RE: ENGINEER'S CERTIFICATION FOR SUNSET FARM WEST UNIT 1 (K-12/D22)
RECEIVED MAY 22, 1996 FOR FINAL PLAT
ENGINEER'S STAMP DATED MAY 21, 1996

RE: DRAINAGE REPORT FOR SUNSET FARMS WEST UNIT 1 (K-12/D22)
RECEIVED DECEMBER 12, 1994 FOR FINAL PLAT & GRADING APPROVAL
ENGINEER'S STAMP DATED DEC 2, 1994

GRADING AND DRAINAGE PLAN
SUNSET FARM -- WEST SUBDIVISION

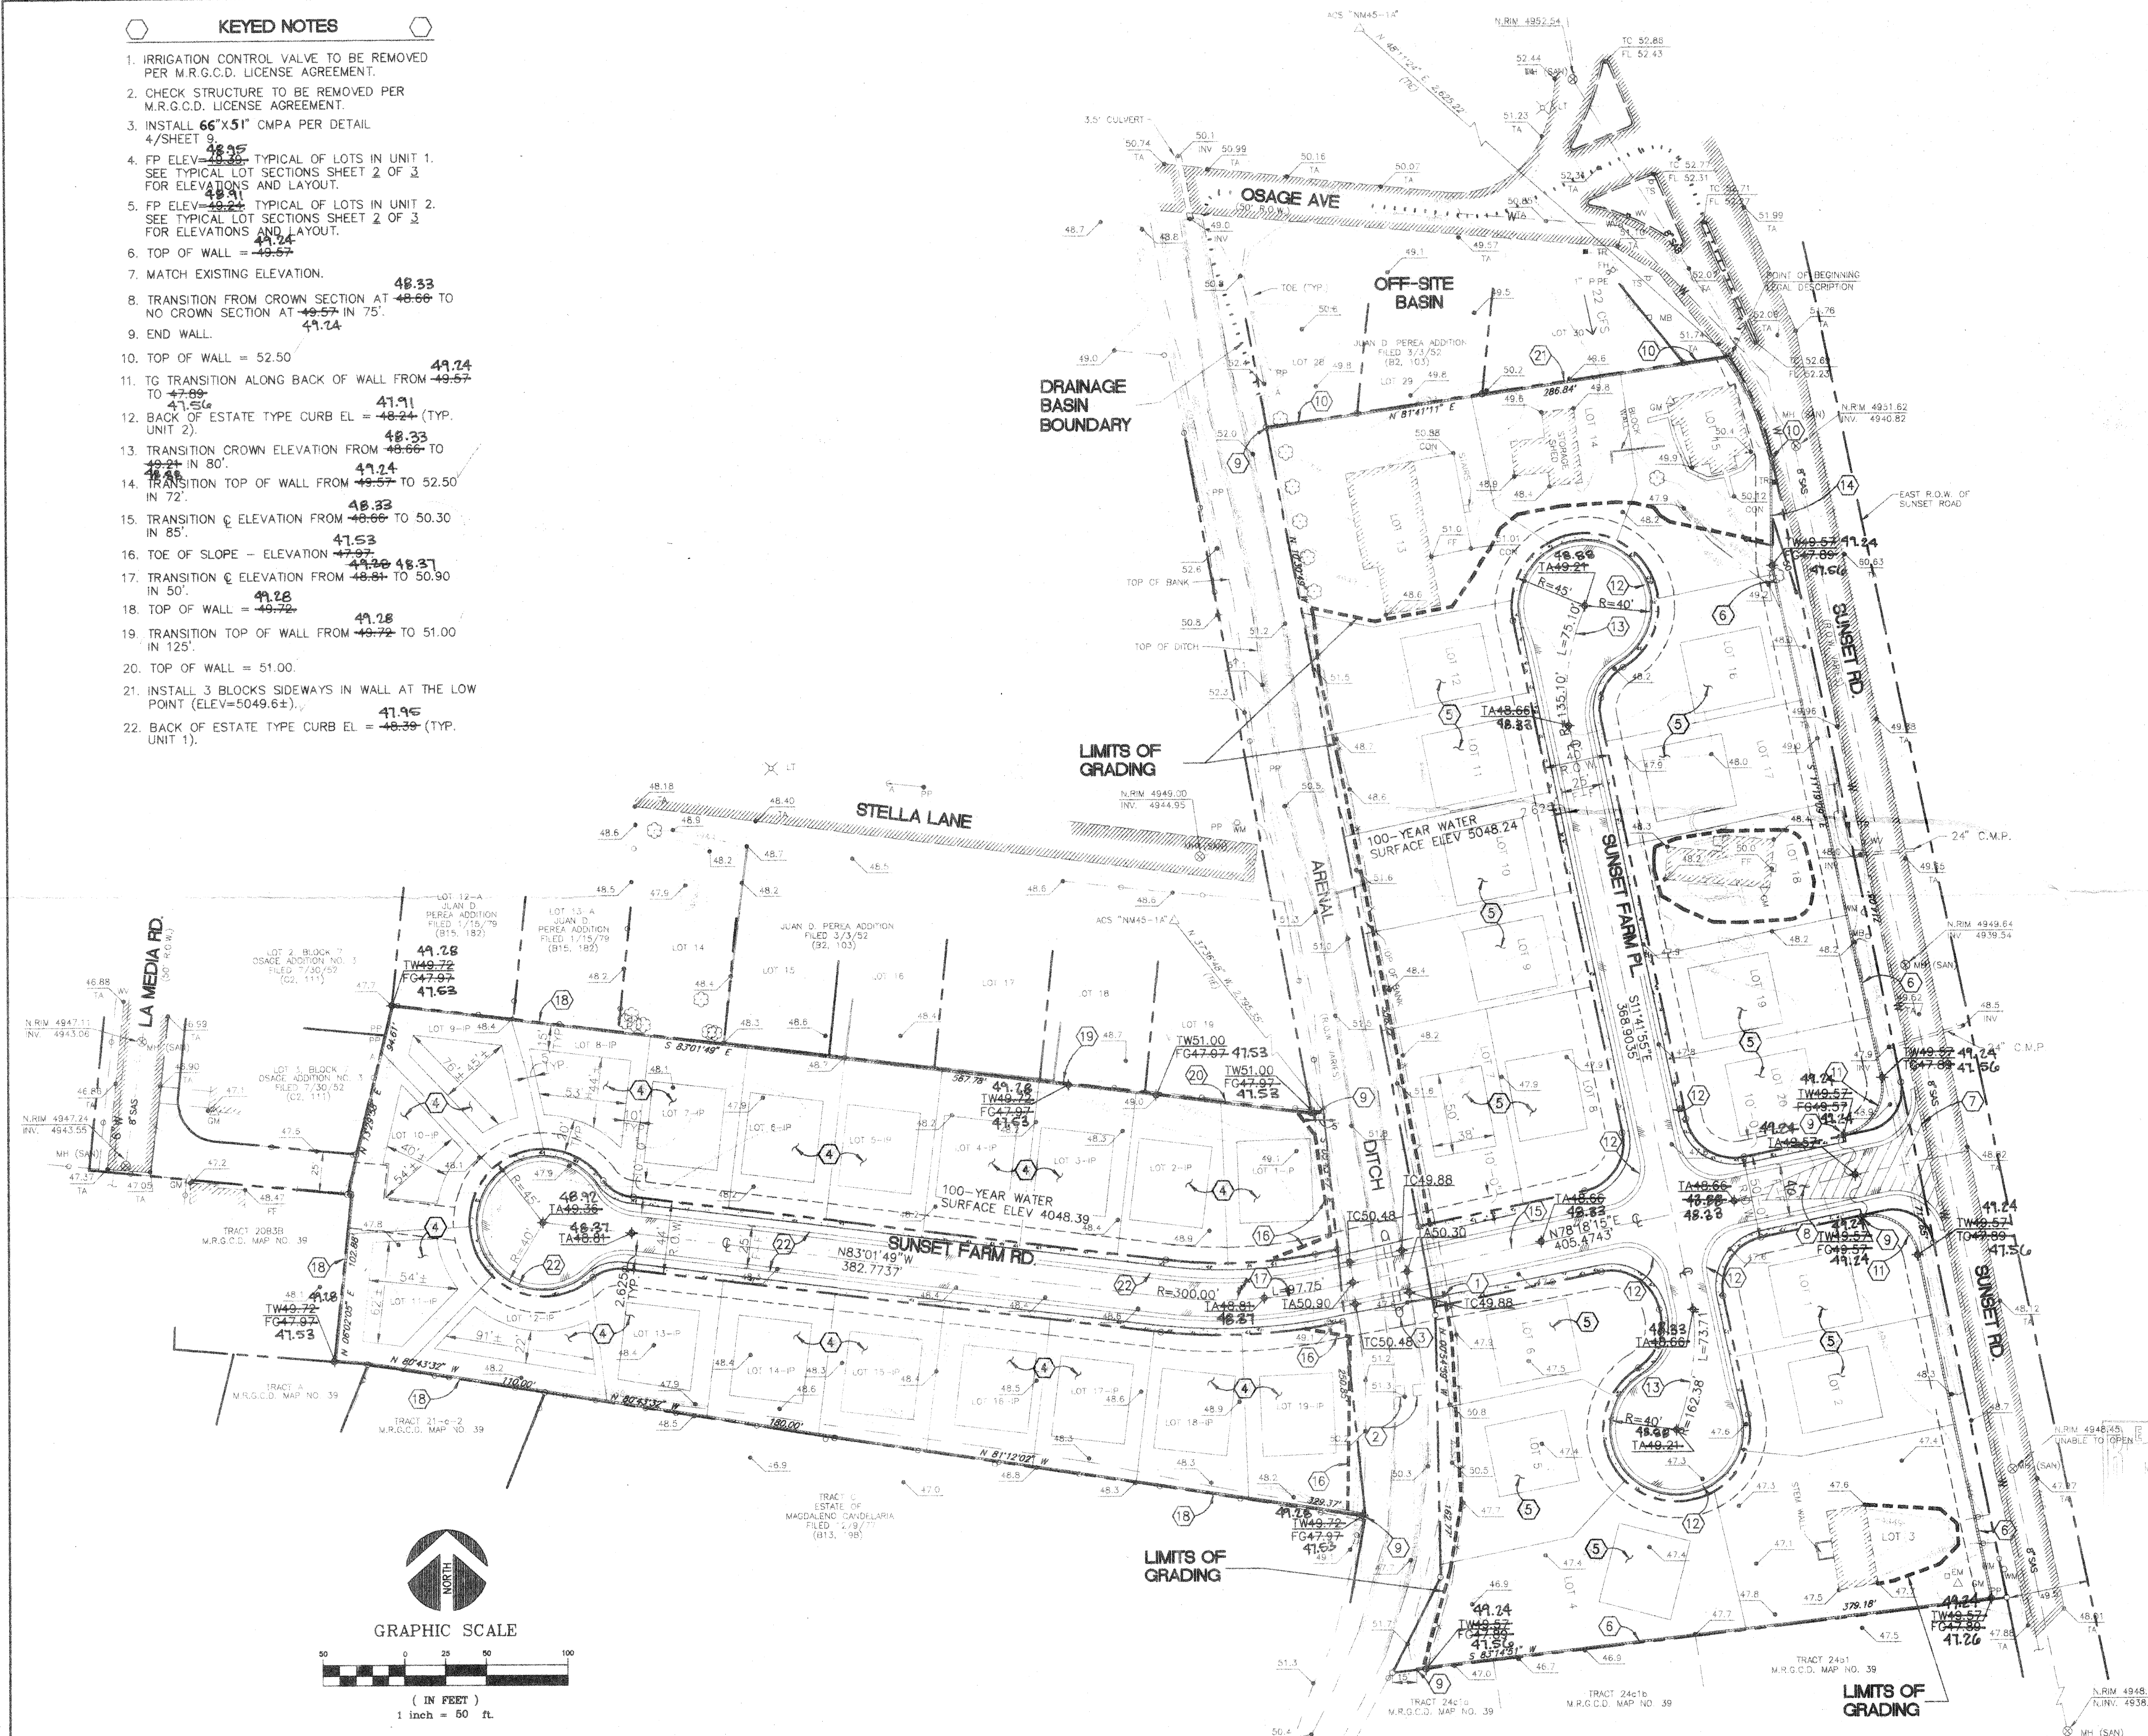
1. IRRIGATION CONTROL VALVE TO BE REMOVED
PER M.R.G.C.D. LICENSE AGREEMENT.
2. CHECK STRUCTURE TO BE REMOVED
PER M.R.G.C.D. LICENSE AGREEMENT.
3. INSTALL **66"x51"** CMPA PER DETAIL
4/SHEET 9.

4. FP ELEV=~~40.25~~ **48.35** TYPICAL OF LOTS IN UNIT 1.
SEE TYPICAL LOT SECTIONS SHEET 2 OF 3
FOR ELEVATIONS AND LAYOUT.
5. FP ELEV=~~40.24~~ **48.24** TYPICAL OF LOTS IN UNIT 2.
SEE TYPICAL LOT SECTIONS SHEET 2 OF 3
FOR ELEVATIONS AND LAYOUT.

6. TOP OF WALL = ~~40.57~~ **49.26**
7. MATCH EXISTING ELEVATION. **48.33**
8. TRANSITION FROM CROWN SECTION AT ~~40.66~~ TO
NO CROWN SECTION AT ~~40.57~~ IN 75'. **49.14**

9. END WALL.
10. TOP OF WALL = 52.50 **49.24**
11. TO TRANSITION ALONG BACK OF WALL FROM ~~40.57~~
TO ~~47.88~~ **47.91**
12. BACK OF ESTATE TYPE CURB EL = ~~48.24~~ (TYP.
UNIT 2). **48.33**

13. TRANSITION CROWN ELEVATION FROM ~~40.66~~ TO
~~40.24~~ IN 80'. **49.24**
14. ~~48.33~~ TRANSITION TOP OF WALL FROM ~~40.57~~ TO 52.50
IN 72'. **49.26**

15. TRANSITION ϕ ELEVATION FROM ~~40.66~~ TO 50.30
IN 85'. **47.53**
16. TOE OF SLOPE - ELEVATION ~~47.97~~ **48.37**
17. TRANSITION ϕ ELEVATION FROM ~~48.31~~ TO 50.90
IN 50'. **49.28**

18. TOP OF WALL = ~~49.72~~ **49.28**
19. TRANSITION TOP OF WALL FROM ~~49.72~~ TO 51.00
IN 125'. **49.28**
20. TOP OF WALL = 51.00.
21. INSTALL 3 BLOCKS SIDEWAYS IN WALL TO THE LOWN
POINT (ELEV=50.49.6+). **47.96**

22. BACK OF ESTATE TYPE CURB EL = ~~48.39~~ (TYP.
UNIT 1). **49.26**

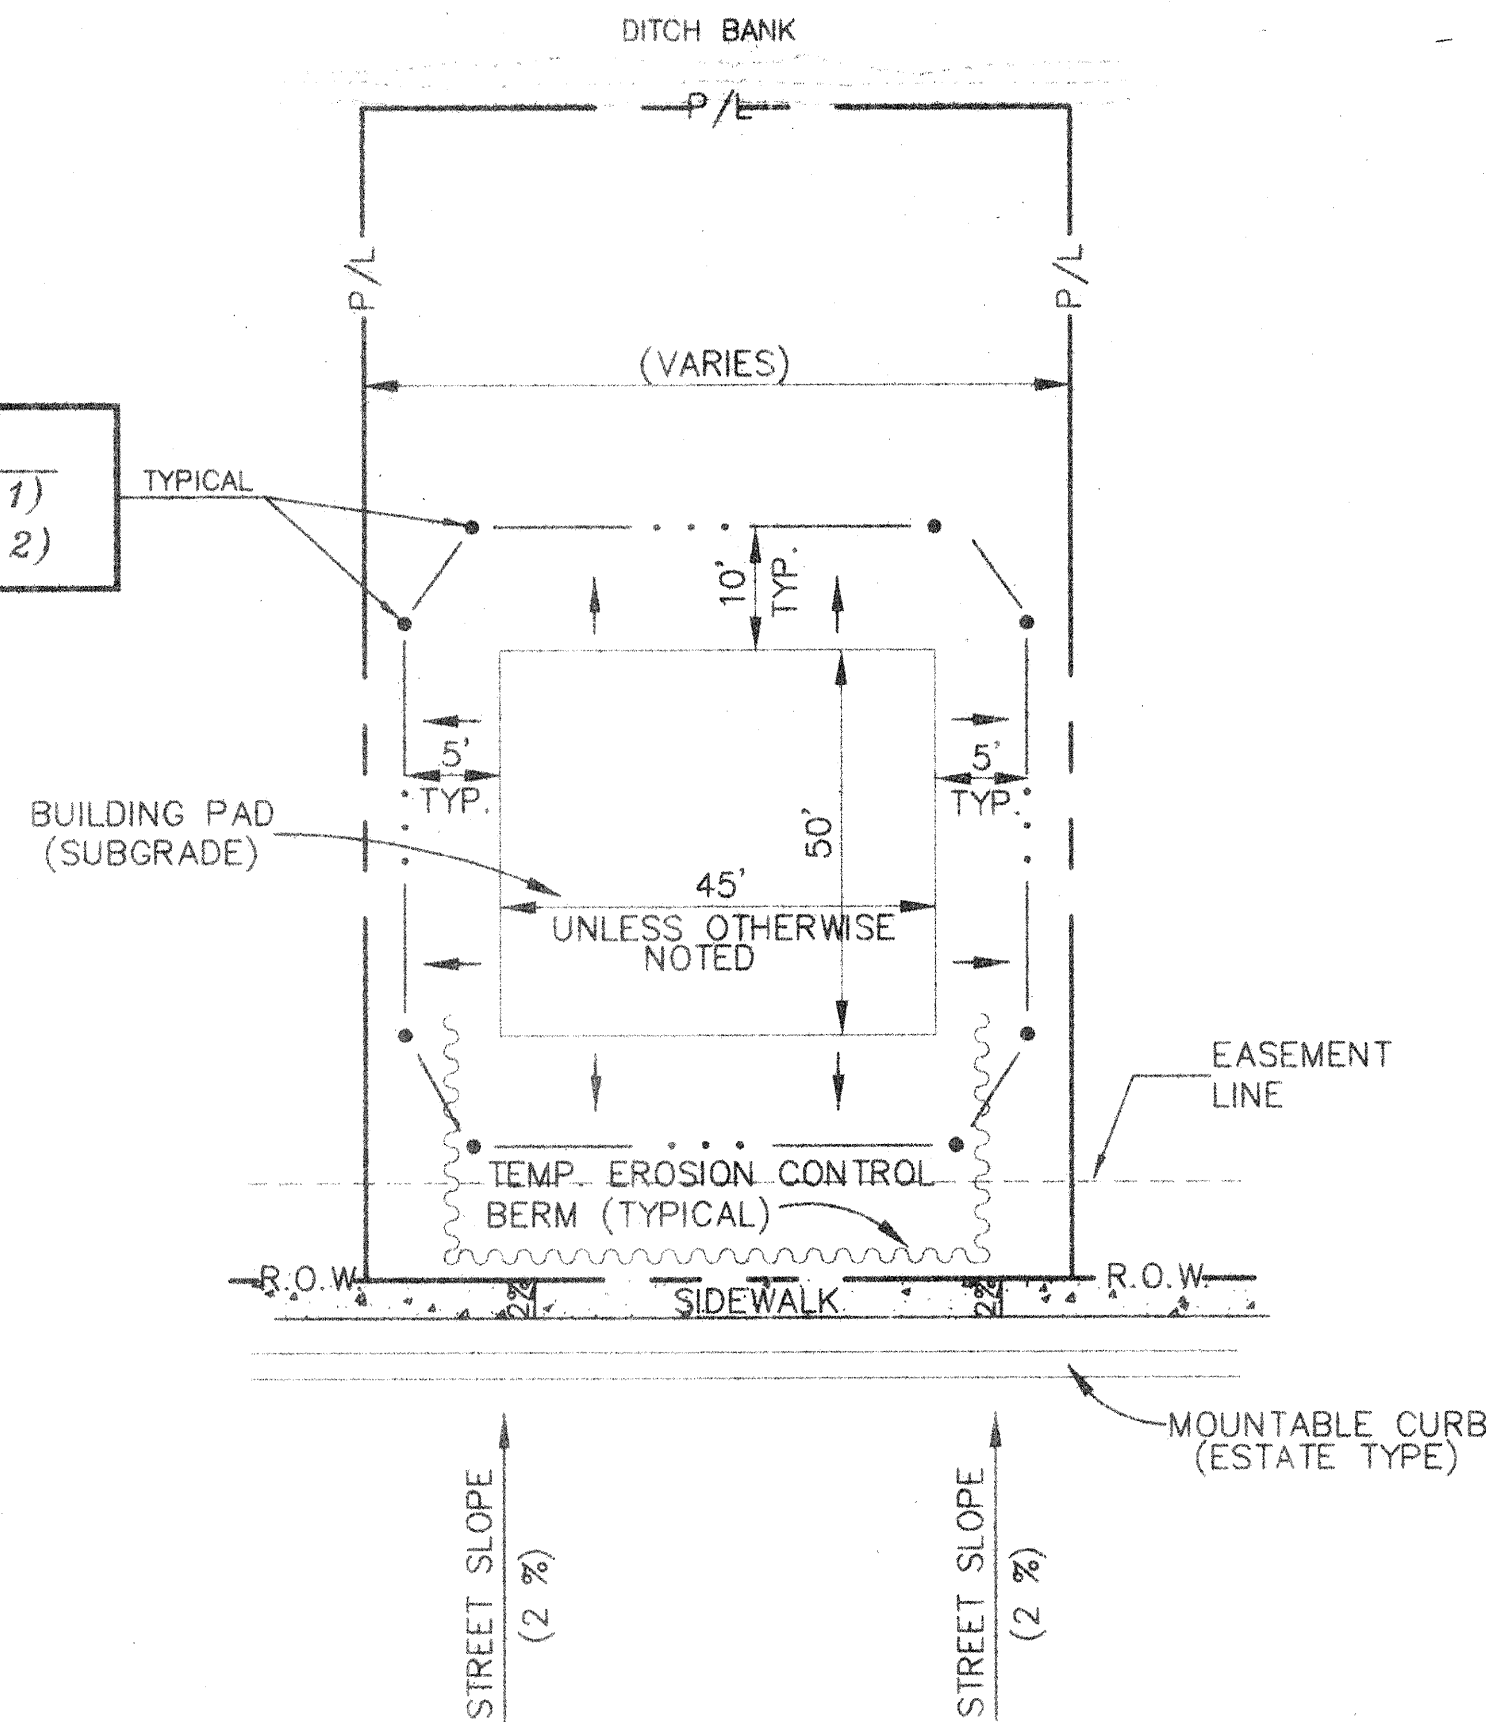
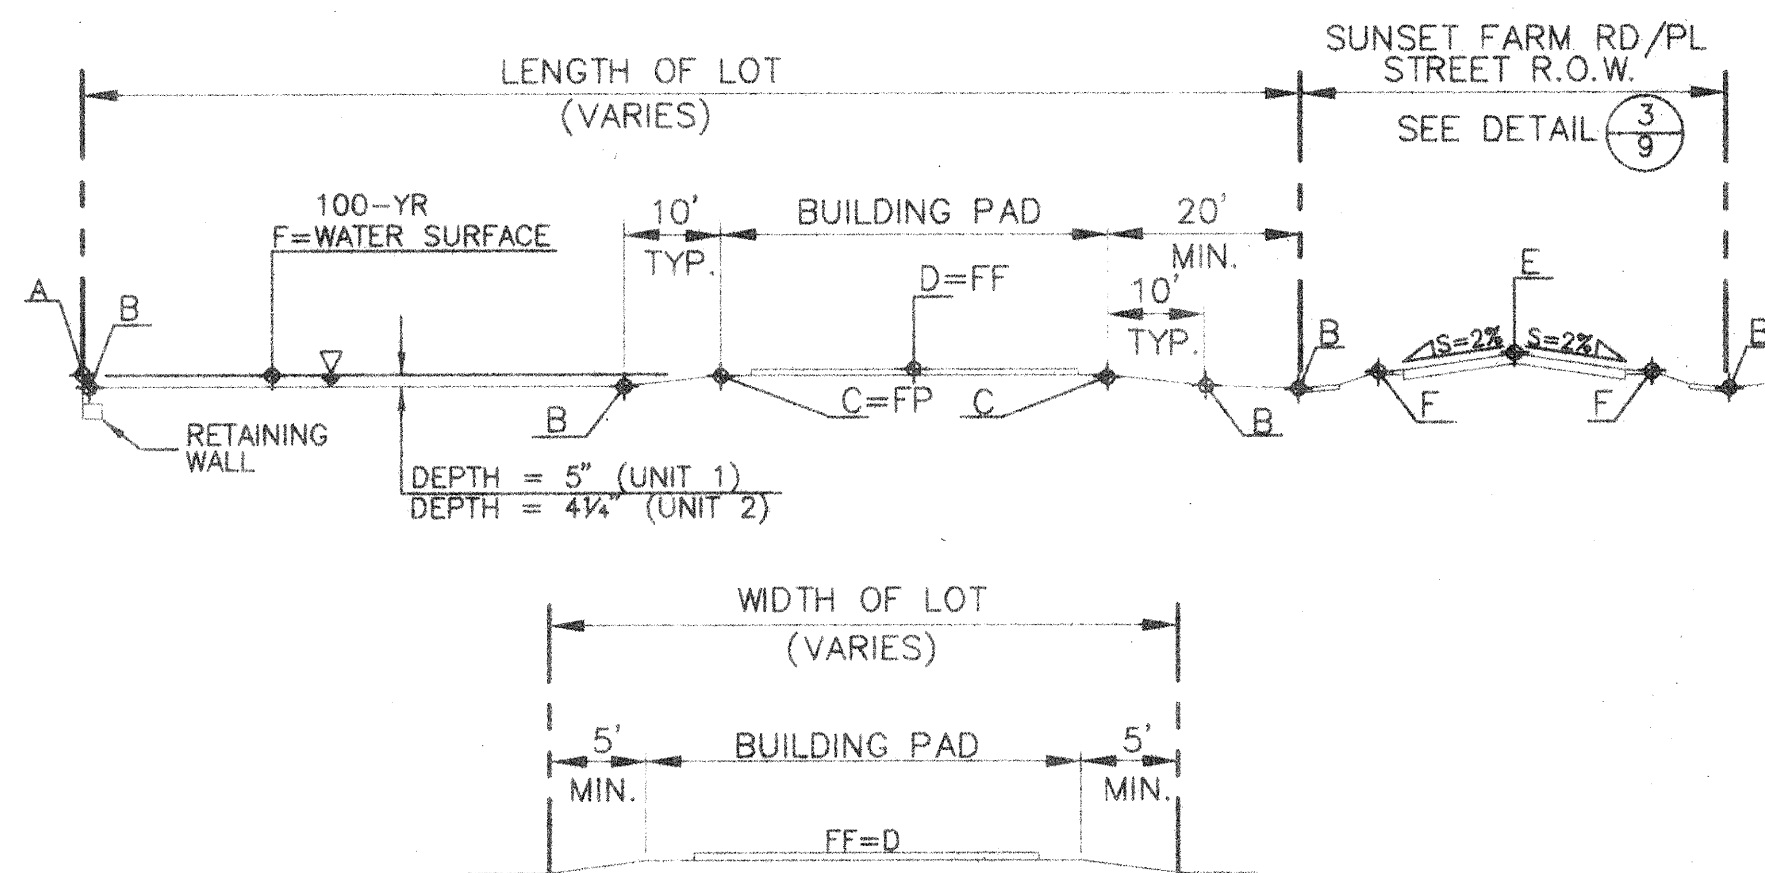
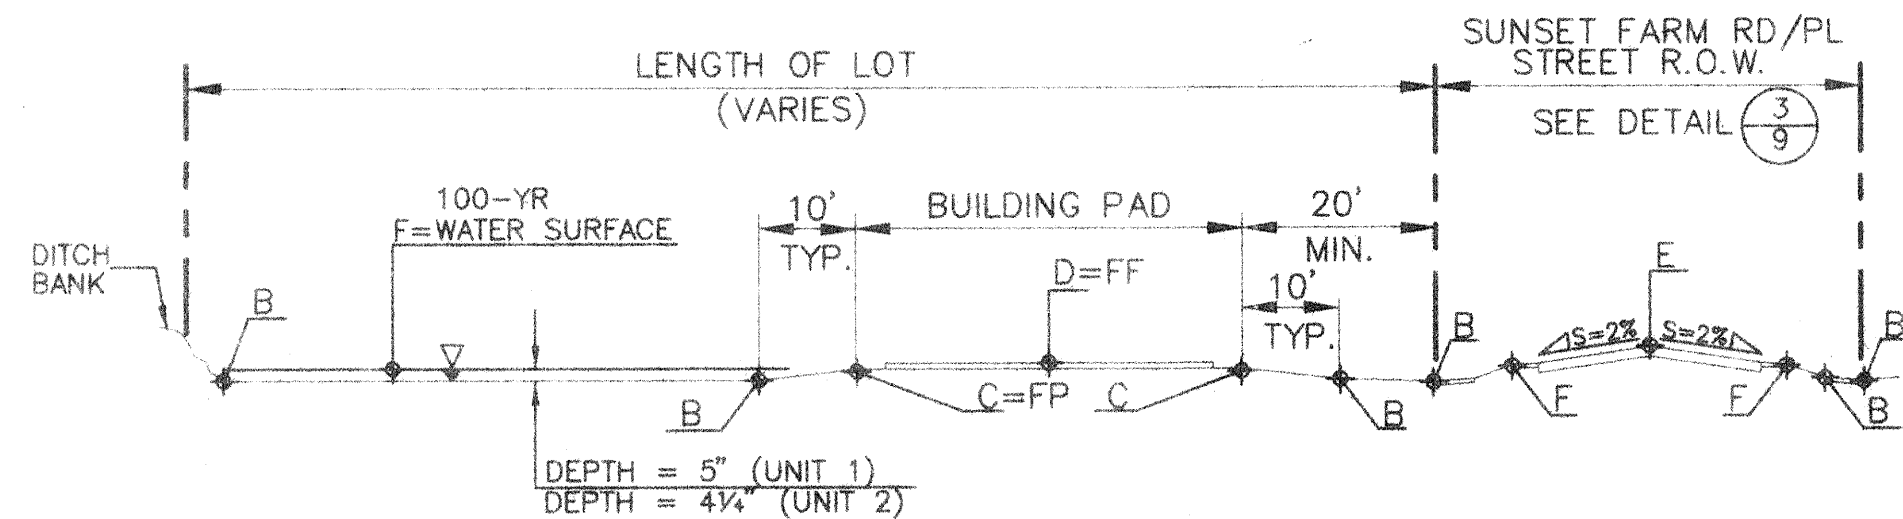
LETTER	ELEV.
A	TW49.7249.24
B	FG47.9747.53
C	FP49.3948.96
D	FF49.7249.24
E	TA48.8148.27
F	TC48.3947.95

LETTER	ELEV.
A	TW49.5749.24
B	FG47.8947.54
C	FP49.2448.91
D	FF49.5749.24
E	TA48.6648.23
F	TC48.2447.91
